City of Portland Design Commission

Design Advice Request

SUMMARY MEMO

Date: September 11, 2023
To: Kurtz Schultz | SERA Design and Architecture
From: Tanya Paglia, Design & Historic Review Team
503-865-6518 | Tanya.Paglia@portandoregon.gov
Re: EA 23-050424 DA – Con-way Block 292 East
Design Advice Request Commission Summary Memo – August 17, 2023 Meeting

SOUTH ELEVATION - NW RALEIGH ST

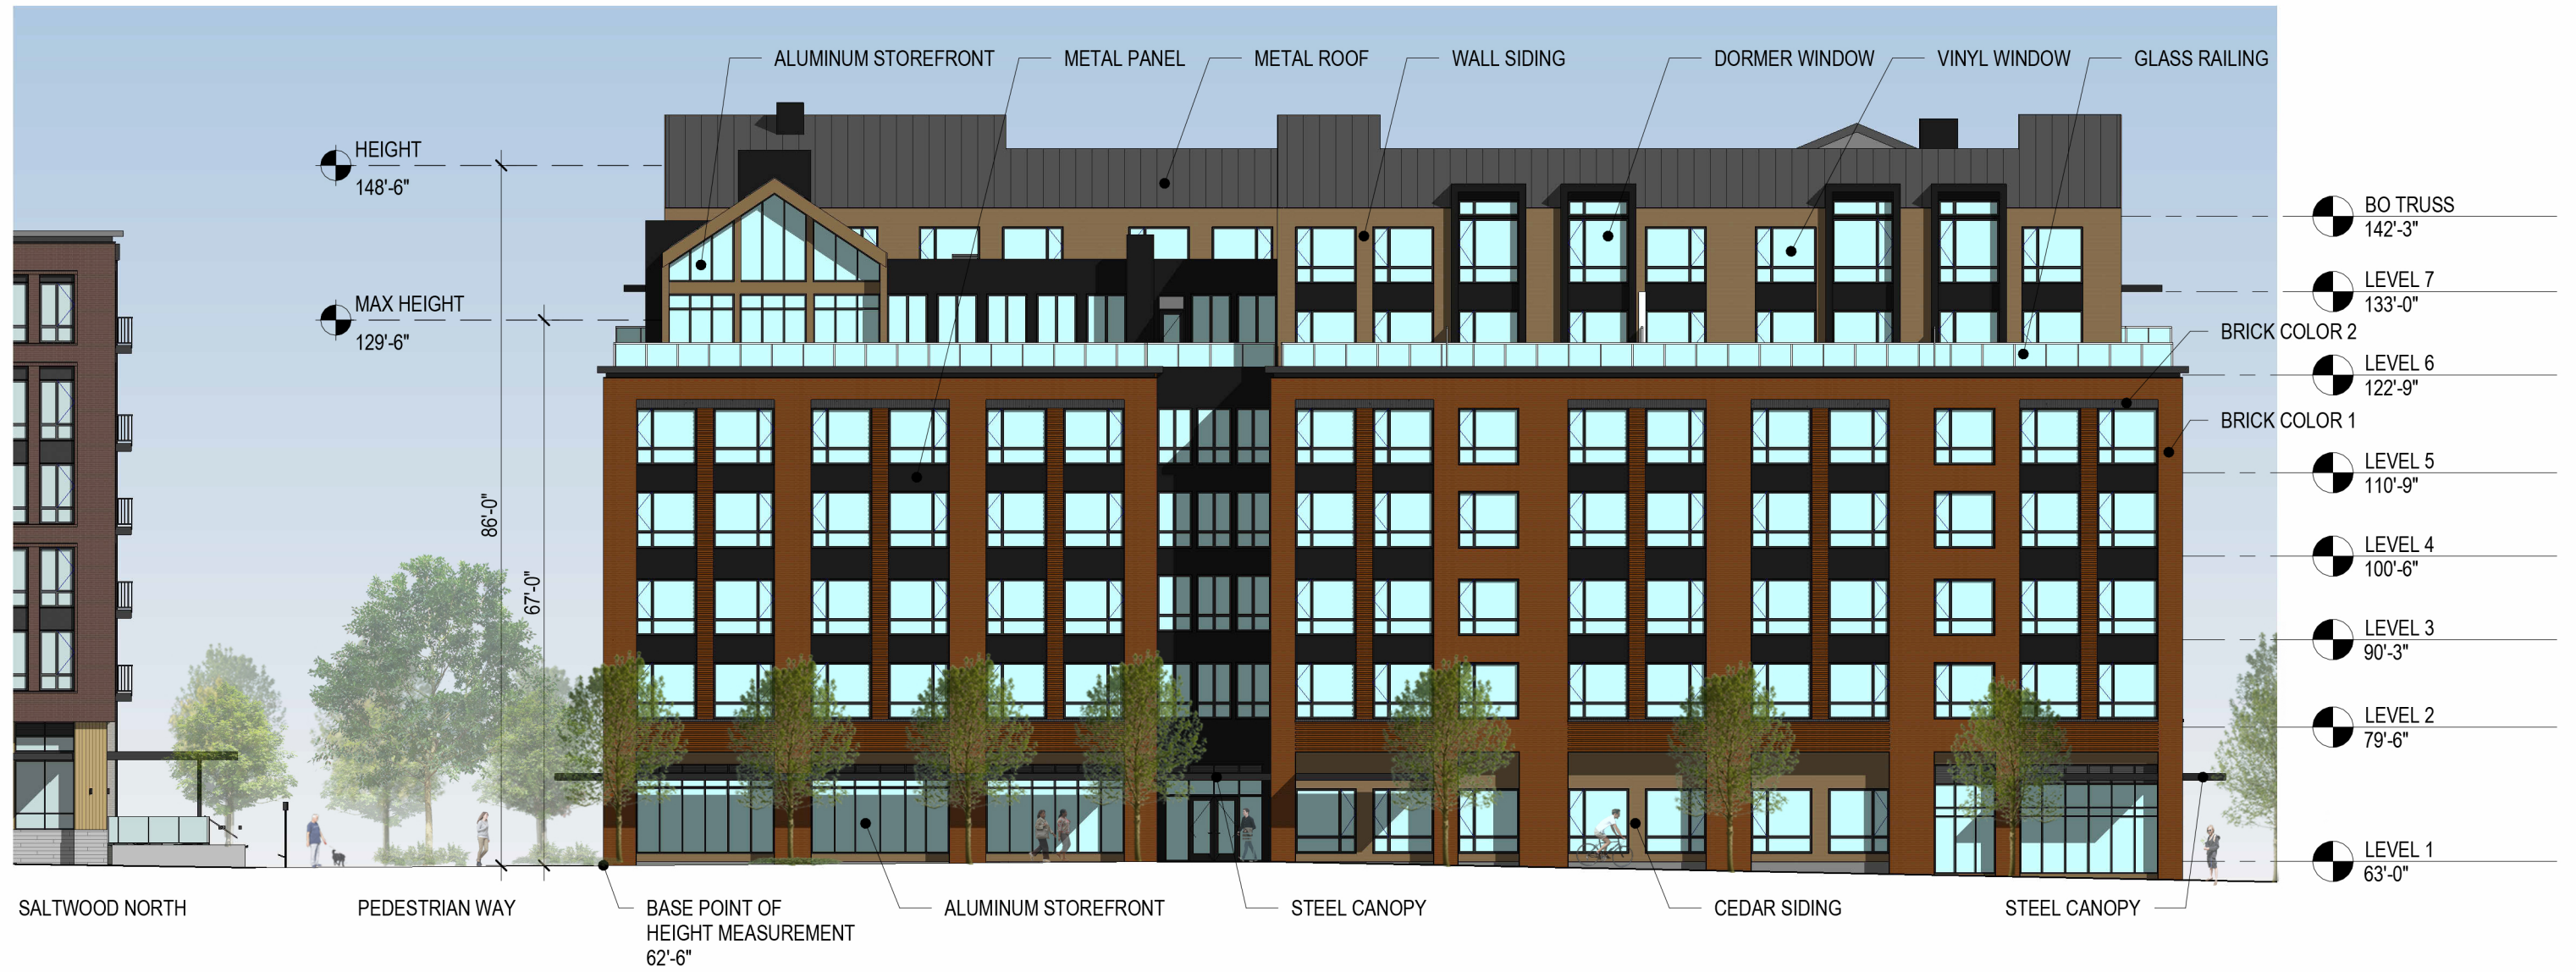
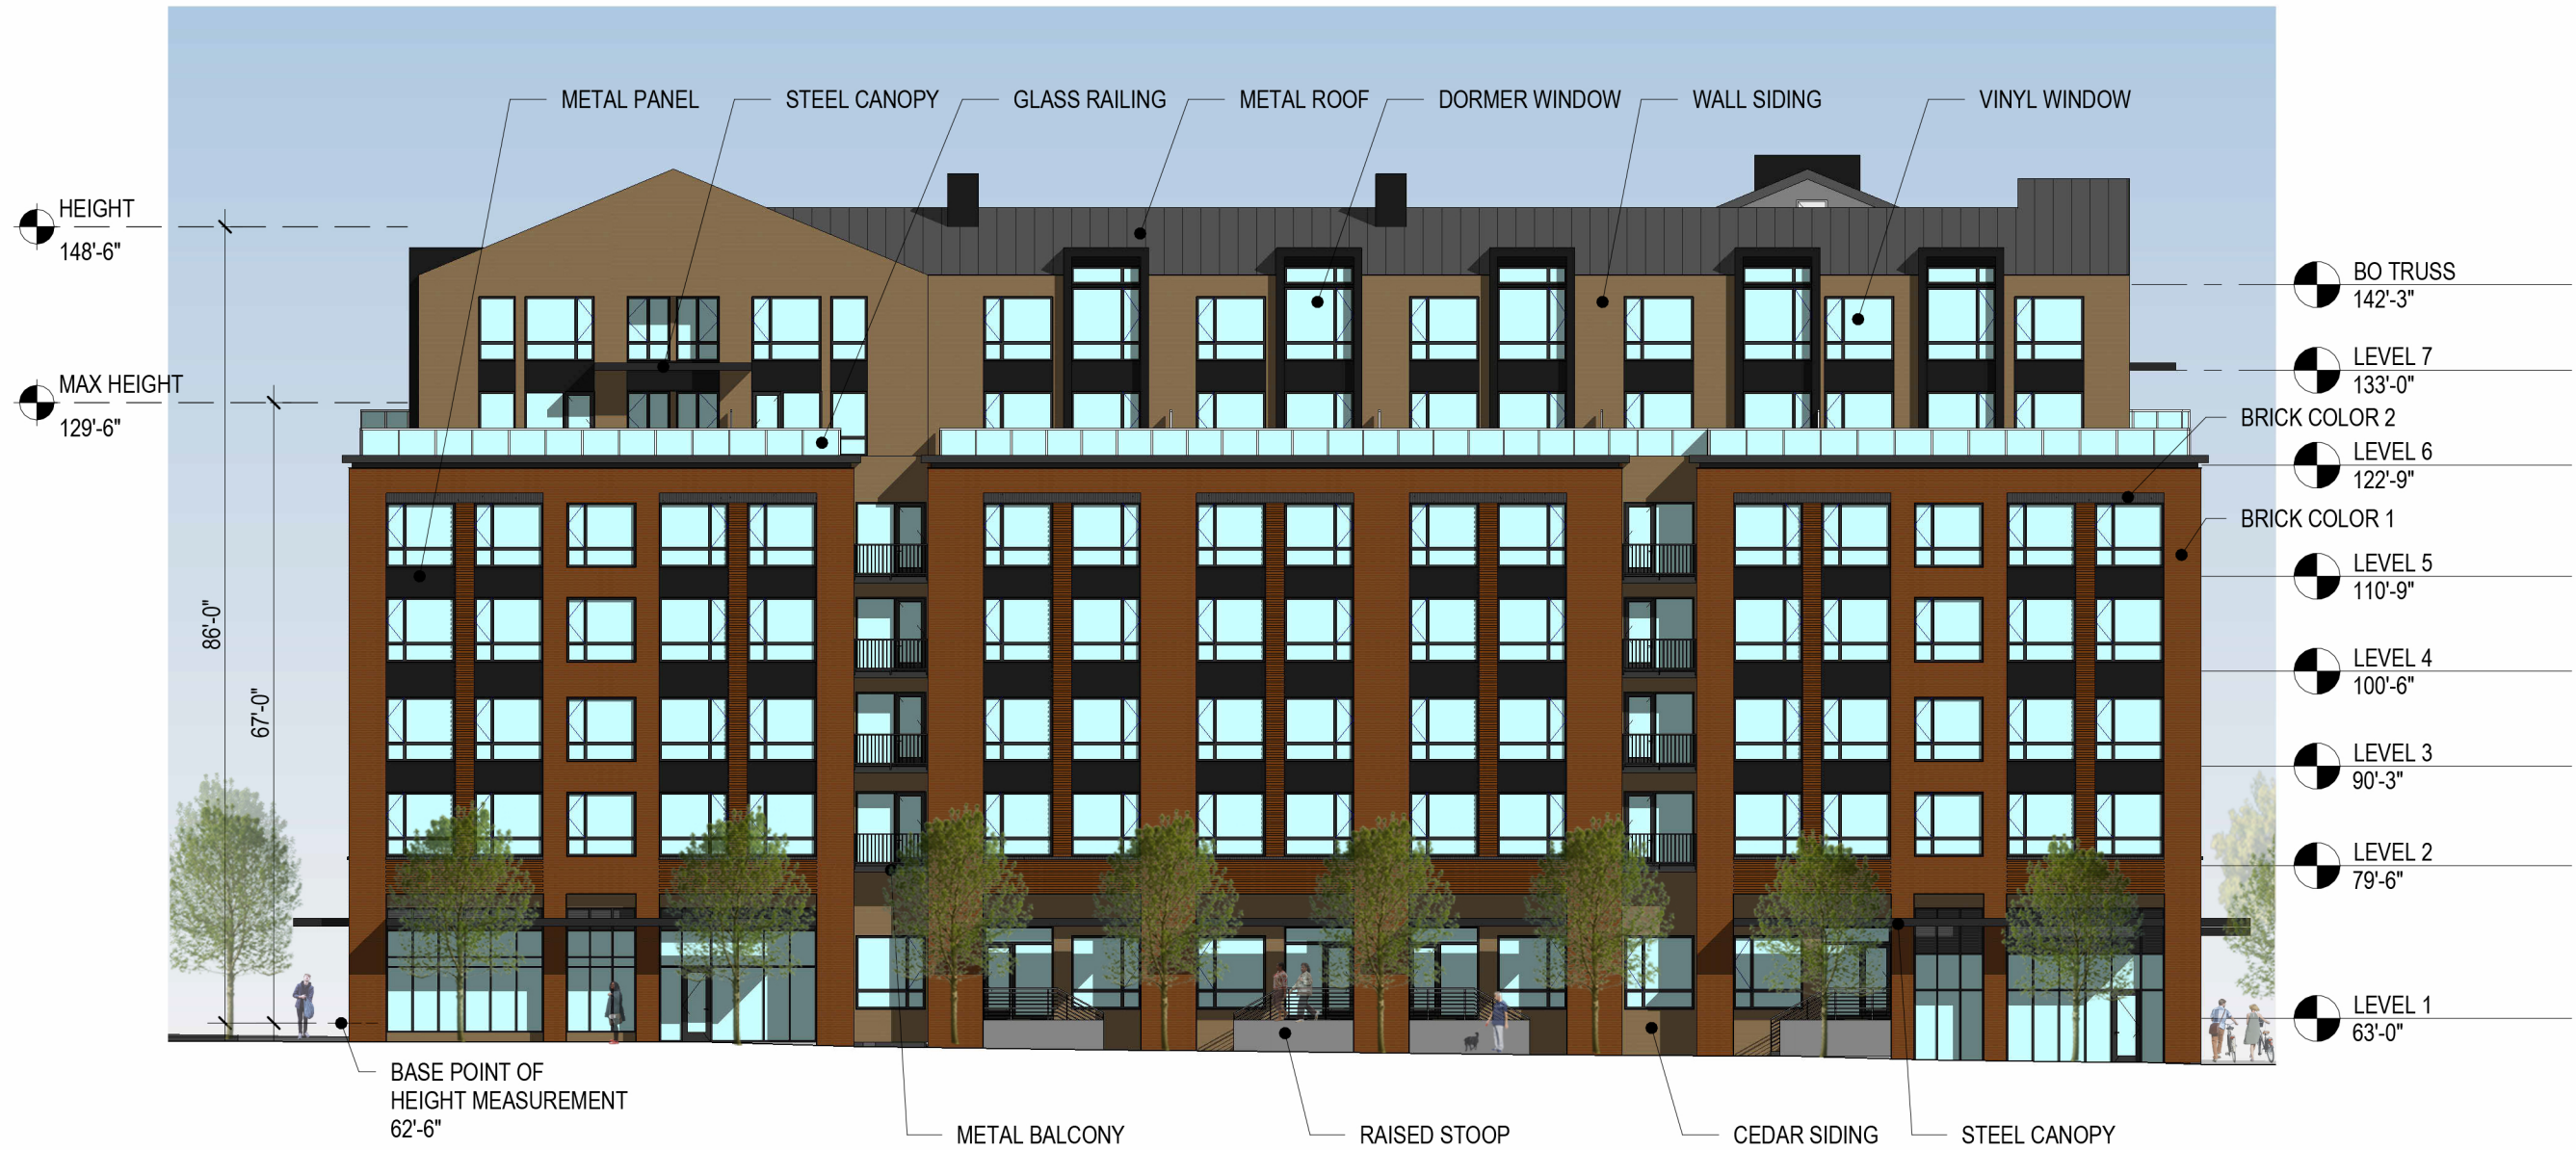
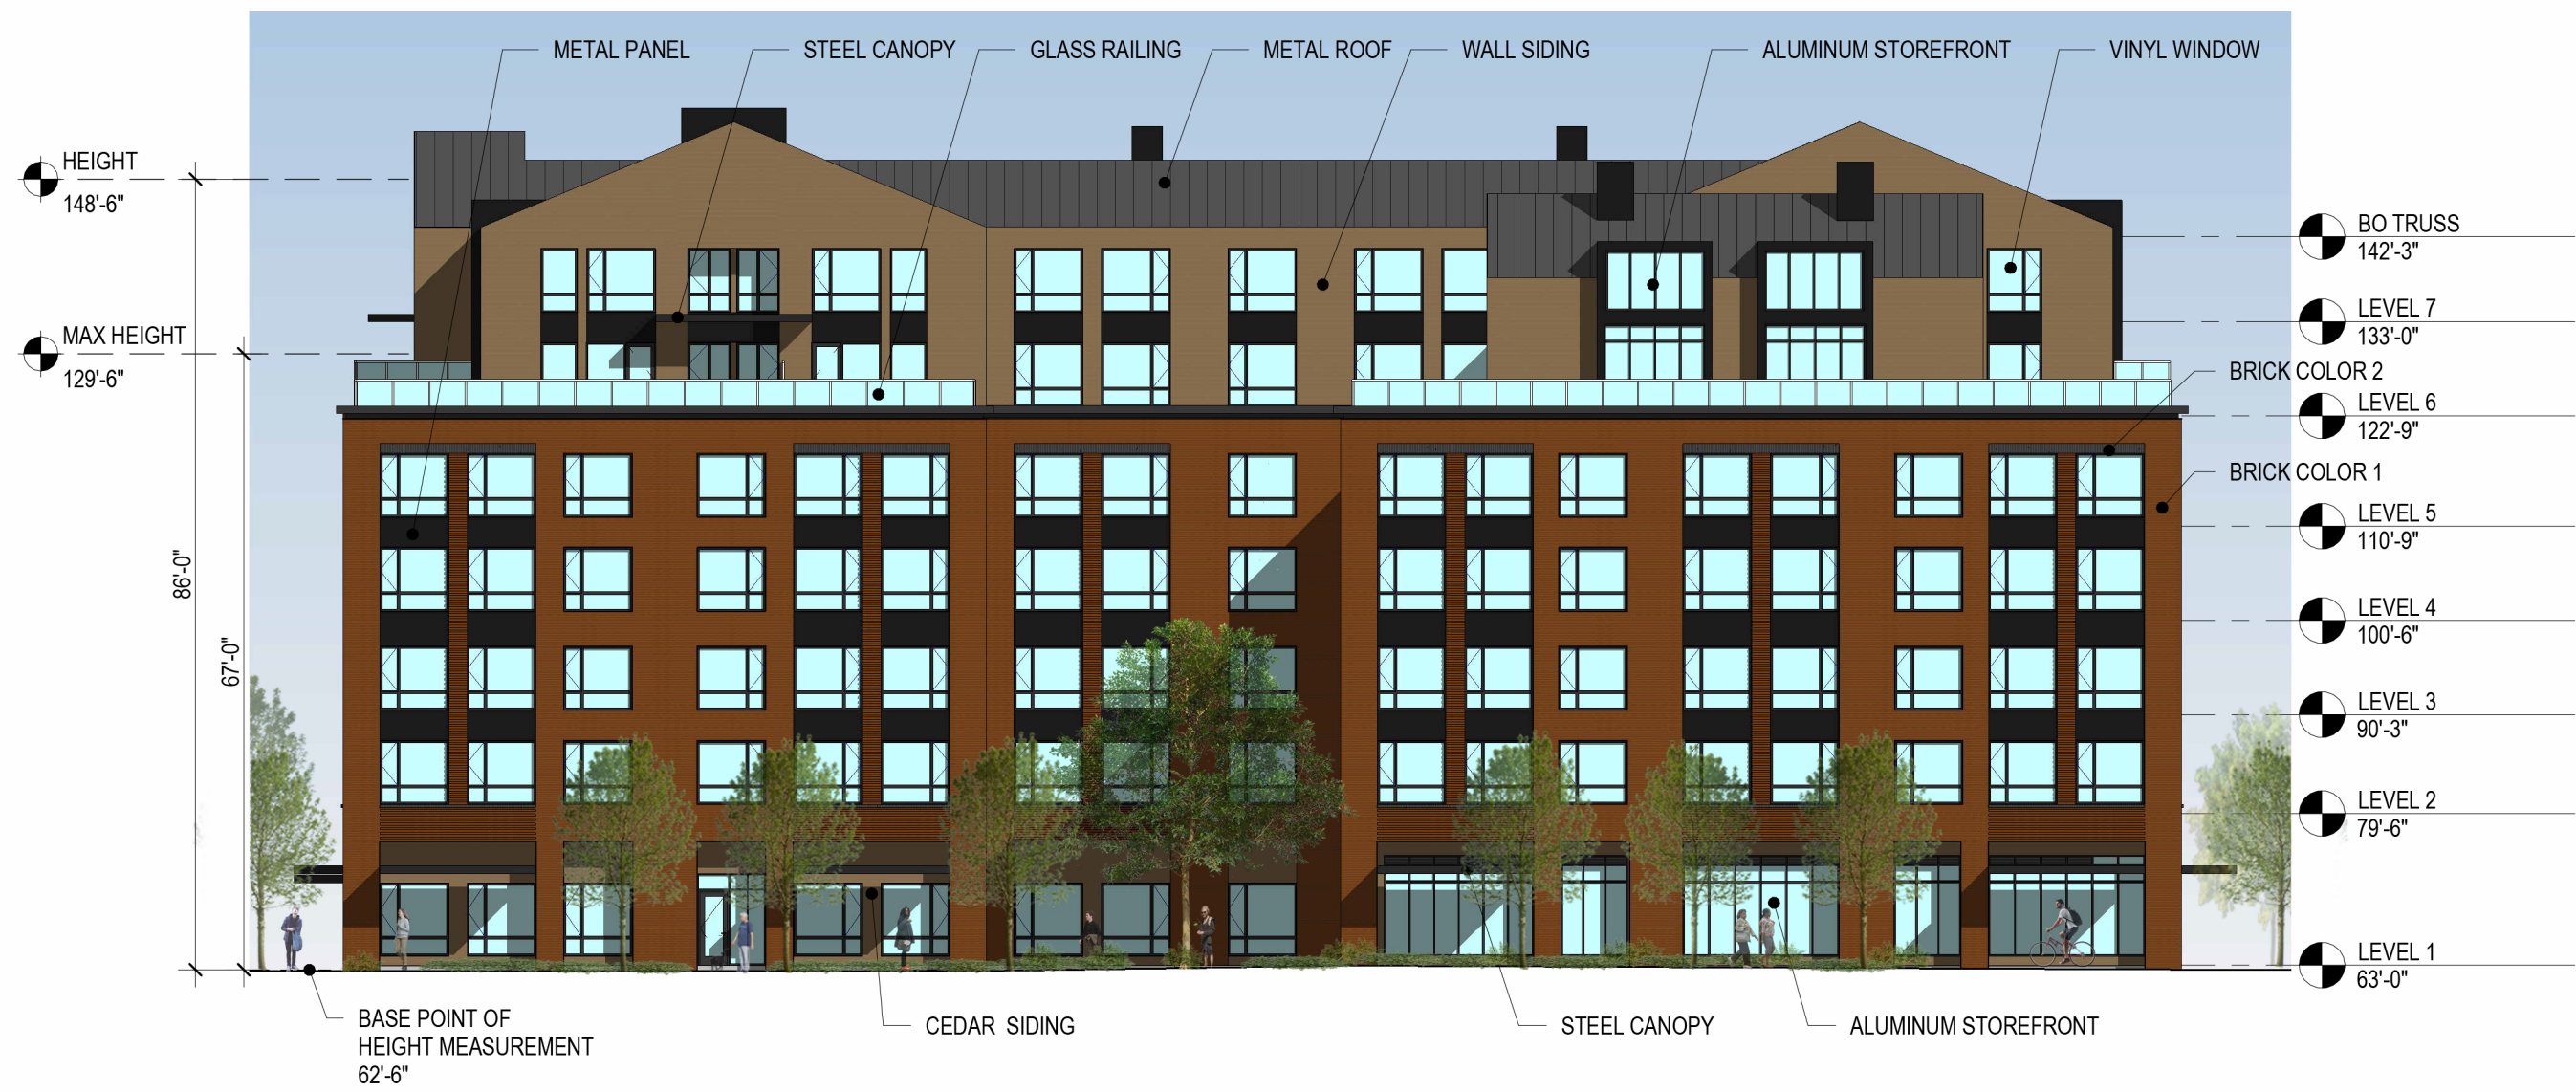
- More specifically, the penthouse is extremely complex while the base is extremely stoic – potentially too much contrast between the two extremes. Simplification of penthouse and/or added detail to the base could create balance.

- The notched area on the Raleigh frontage needs a clearly different glazing system to set it apart and break the façade to create the pavilion experience and accentuate the main entrance.

- The three ground floor units on NW Raleigh Street need to be further developed.
- Color studies for the base building as well as the penthouse levels are needed to better understand if more contrast would be preferable and/or other color palettes would work better.

- The three ground floor units on NW Raleigh Street need to be rethought. They need to be designed to be convertible if future commercial use becomes in demand. Some commissioners found them to be inappropriate to the frontage and suggested relocating amenities to this area, while other noted that the units need to develop a stoop system, and softness should be added in the front via landscaping.
